Service Bulletin No. 95-001

M3 Option Card PCB Modification

MODEL: Micro Lynx M3 Option Card

SERIAL NO: All M3 Option Cards prior to Serial Number 430

Figure 3. Component Location

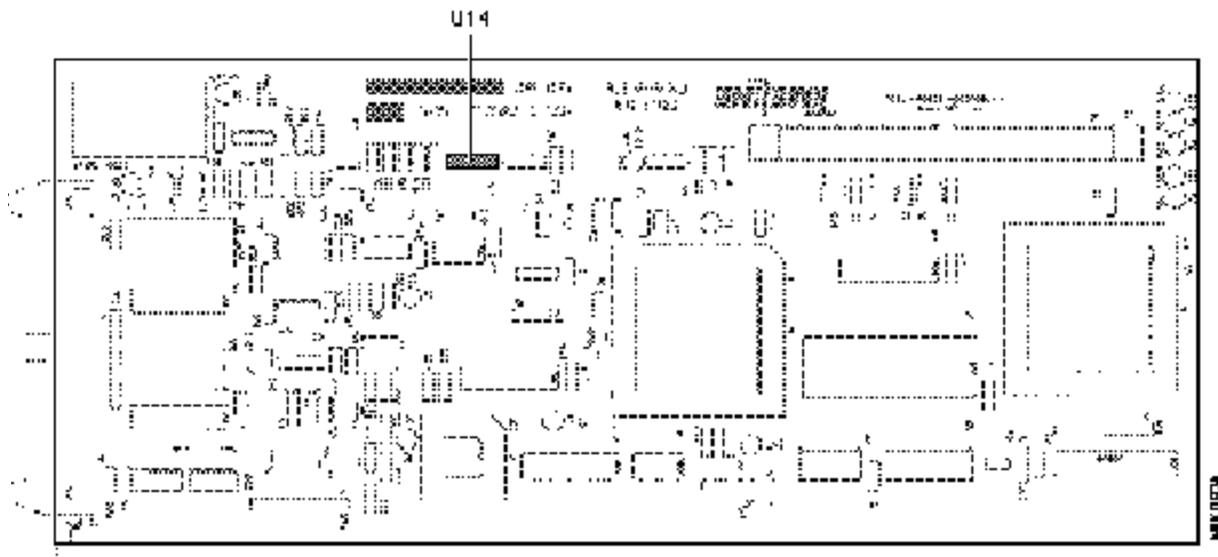
In some Micro Lynx M3 Cards, the M3 Bandwidth Select analog switch works intermittently. This is due to the IC at U14 being operated out of its recommended voltage supply range, depending on the manufacturer of the part.

5. On the M3 Option Card locate U14. (See Figure 3) If the IC is made by National, SGS Thompson, Phillips or Signetics, contact TimeLine for an RMA number. This component will need to be replaced.
